Action Taken Report (Response) by Jharkhand State Pollution Control Board (JSPCB)
in O. A. No. 479/2022 in the matter of Krishna Chouhan Vs State of Jharkhand.

Sub:- Show cause notice under section 21 (4) of the Air (Prevention & Control of Pollution) Act, 1981 and under section 25/26 of the Water (Prevention & Control of Pollution) Act, 1974-Regarding.

Sub: Reply/Action Taken Report of Project Proponent with ref to Show Cause Notice Dated 21/12/2022

②

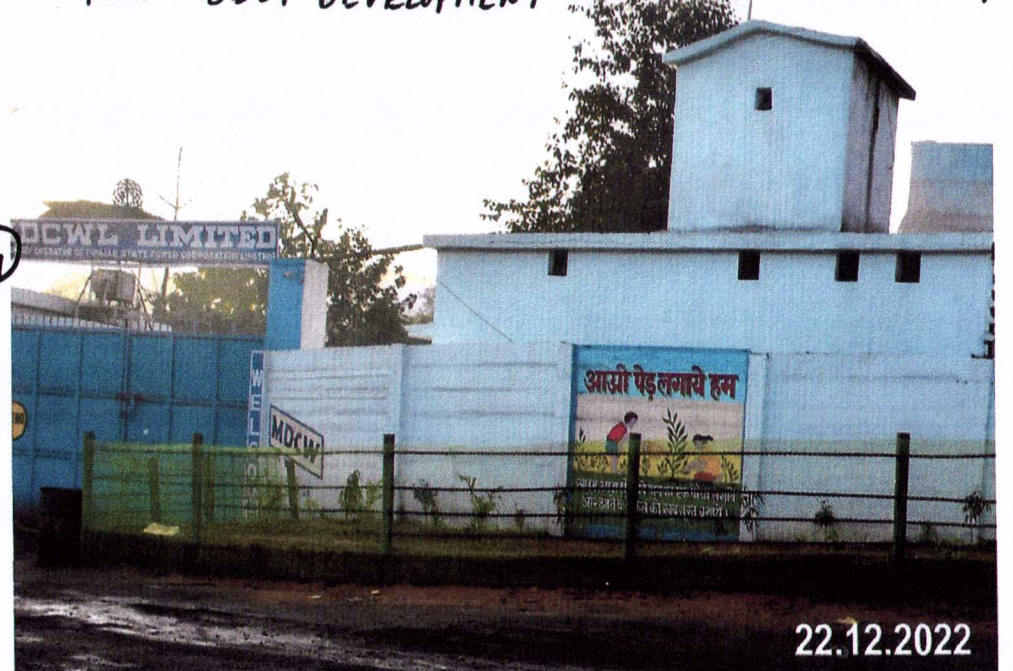
h. Plantation/green belt development around the project boundary, in the gaps between already existing trees, inside the project areas should be developed.

GREEN BELT DEVELOPMENT AROUND PROJECT BOUNDARY
